Eagle Quarter II, Newbury

Response to West Berkshire Council's Highways Comments

Document Reference: WIE18916-113.R.1.4.3

Photograph 1 - Market Street Pedestrian Crossing

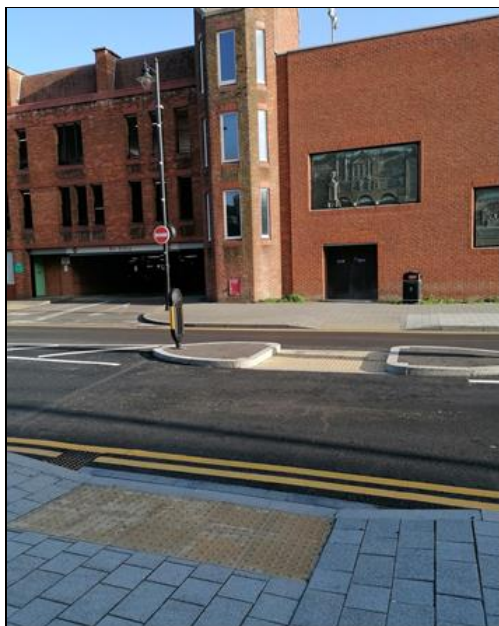
WBC Paragraph	Comment	Status
	<ul style="list-style-type: none"> There is concern regarding the lengths that pedestrians would have to cross at the Bartholomew Street / Market Street junction are at the upper end for a single stage crossing. This will increase the crossing time for pedestrians and due to the traffic movements result in a dedicated pedestrian stage which may affect junction capacity and queues in the area. Consideration should be given to keeping the central pedestrian island and banning the right turn out of Bartholomew Street fronting the site and forcing all traffic to turn left thereby allowing pedestrians to cross in shorter times. Also are the splitter islands wide enough for the proposed signal head configuration? The northbound stop line in Bartholomew Street opposite Jones Robinson estate agents may need to be set back further for allowances to be made for the adjacent loading bays. It can also be difficult to get a 12.0 metre bus around from Market Street into Bartholomew Street when there is a vehicle sat at the northbound stop line and on the road centre line. The highway alignment in Market Street has changed significantly since the documents were drawn up, and this should be checked. Following consideration on potential redesign of the traffic signal junction, further traffic modelling results will need to be submitted for this traffic signal junction

The existing pedestrian crossing to the east of the MSCP on Market Street includes tactile paving and a central refuge, as illustrated in Photograph 1 below. This crossing was reinstated to suit the new footway alignment which formed part of the Market Street S278 works.

We consider the existing crossing to be more than adequate for the speed and volume of traffic on Market Street. Furthermore, there have been no recorded collisions at this crossing point over the most recent 3-year period (2020-2022). Nevertheless, we would be happy to investigate potential improvements to this crossing. Please could you advise what improvements you consider appropriate. We will then prepare a design for your comments/approval.

Figure 2 – West Berkshire 019 Super Output Area

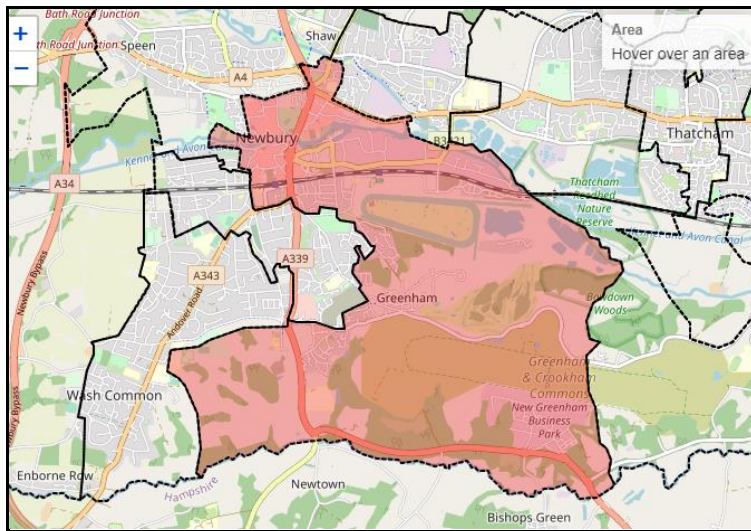
WBC Paragraph	Comment	Status
	<ul style="list-style-type: none"> 1 visitor space is required per 5 apartments. 	
19	Based upon the above standards the residential proposals would require 386 parking spaces plus a further 85 visitor parking spaces. The total parking provision required for residents is 471 vehicle parking spaces	No action required
20	The existing Kennet Centre MSCP currently includes 415 spaces and is owned by the applicant and leased to West Berkshire Council. The car park is available to the public and allows for both short and long stay parking. The pricing structure includes hourly, daytime, overnight and quarterly charges. Overall, a further 60 car parking spaces is being provided with the proposal to bring the total provision to 475.	No action required
21	I have read Section 7 of the TA titled Parking Rational. This site along with all other sites within the town centre and across the district must comply with the Councils car parking standards. It was made quite clear in discussions held in the summer, that this site is not considered to be an exceptional in any way. It is disappointing that such a claim is still being made. Contained with Section 7 is census data, in an attempt to justify a lower provision. However, as explained in the summer, census data was already considered when producing the parking standards that are set out in Policy P1 along with accessibility, etc. Policy P1 will be applied and will defended	Response provided in section 3

- Car ownership statistics for flats/apartments within the West Berkshire 019 super output area (illustrated in **Figure 2**), indicate ownership levels of 0.63 cars/vans per household in 2011 and 0.68 cars/vans per household in 2021 (provisional estimate). The proposed level of parking provision exceeds these figures by providing 0.70 spaces per apartment during the peak non-residential period. Outside of this period, residential parking provision exceeds 0.70 spaces per apartment.

E. Refuse Vehicle Tracking

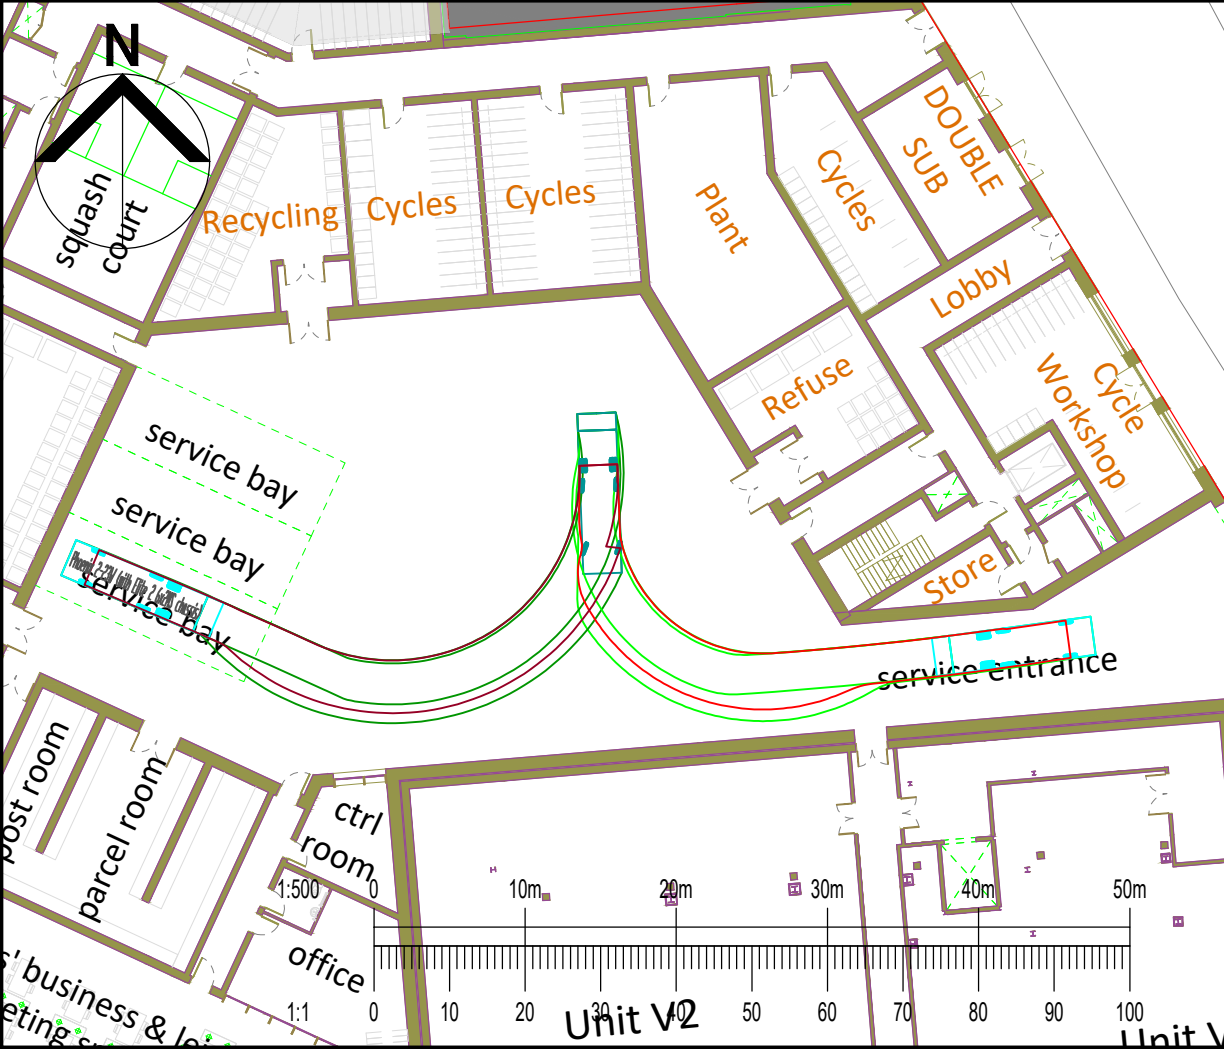
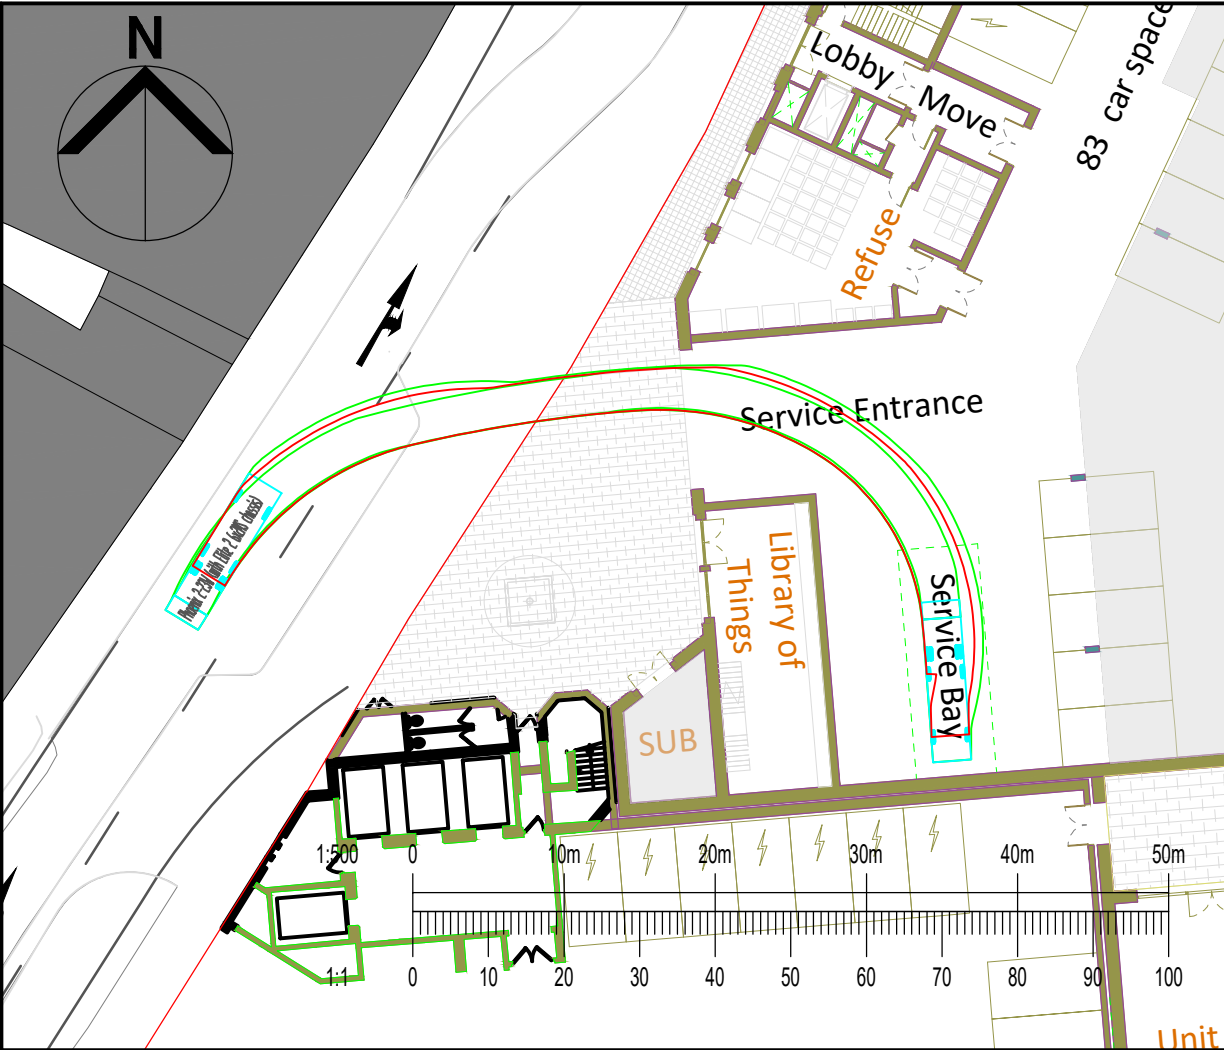
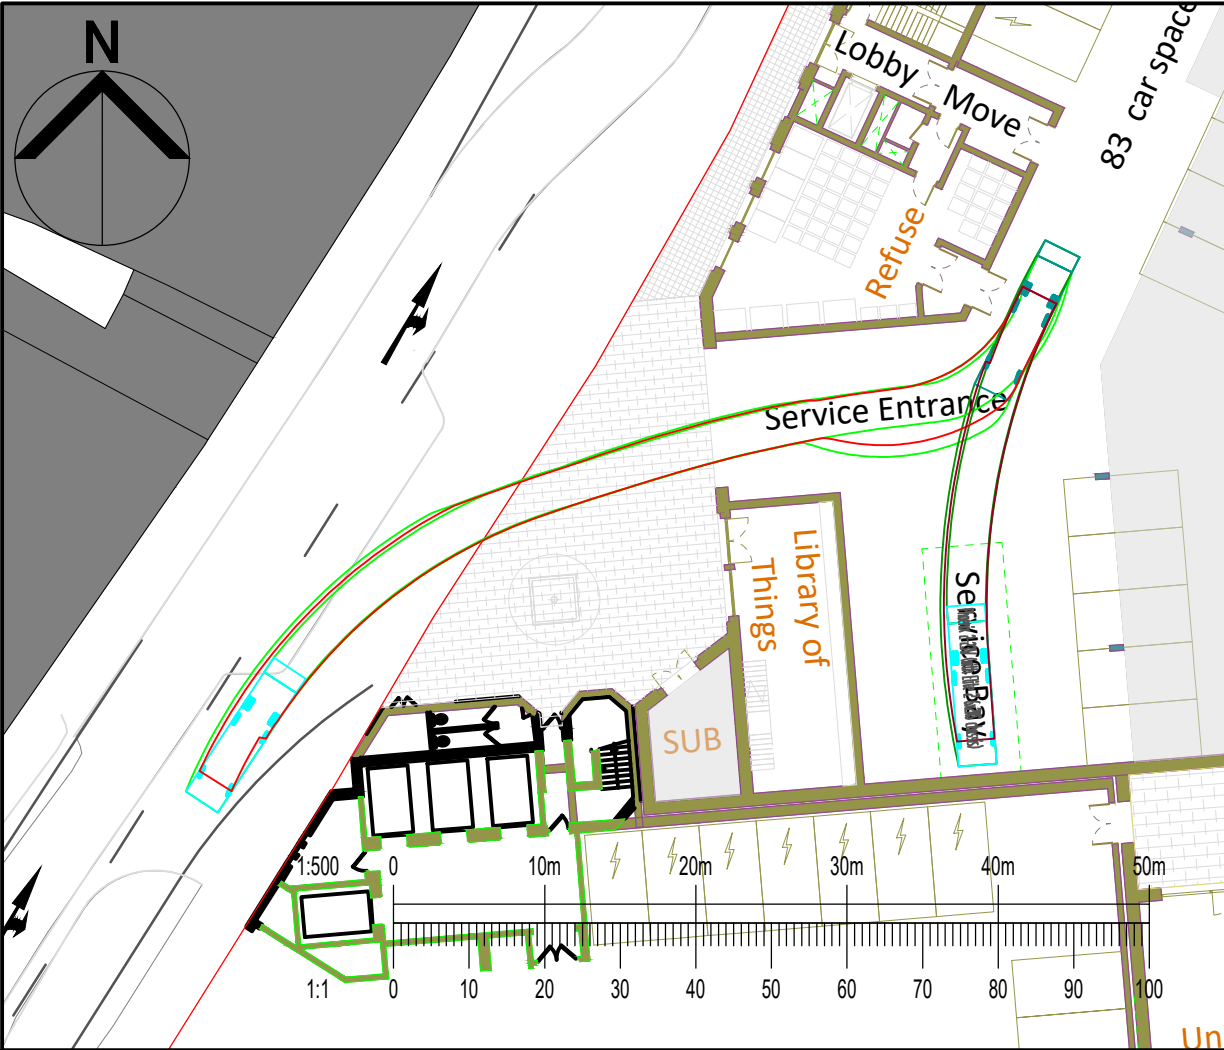
14	There is concern about service access and car park access being in the same place with service vehicles mixing with a car park. Service area should be kept separate from the car park movements. I am assuming that the proposed car park will be used by residents only.	Response provided in section 3
15	There is concern over the routes cyclists will need to take to get to the cycle stores including through proposed car parks	Response provided in section 3
16	I am concerned however, that larger vehicles such as HGV's will be unable to use either of the new accesses. I consider this is an issue that should be addressed. Will HGVs be likely to visit the site?	Response provided in section 3
17	Nine separate secure storage areas are proposed on the ground floor, totalling 632 spaces, with a range of tiered bike racks, Sheffield stands and secure lockers for storage. A number of visitor cycle parking spaces would also be provided within the site. It would seem that the development complies with the Councils Cycle and Motorcycle Advice and Standards for New Development.	No action required

Vehicle tracking is also included to demonstrate that refuse vehicles would be able to safely access, egress and manoeuvre within the proposed undercroft service area. A drawing to illustrate this is included as part of **Appendix E**. Also included on the drawing is the vehicle tracking for the Cheap Street service area.

Vehicle tracking is also included to demonstrate that refuse vehicles would be able to safely access, egress and manoeuvre within the proposed undercroft service area. A drawing to illustrate this is included as part of **Appendix E**.
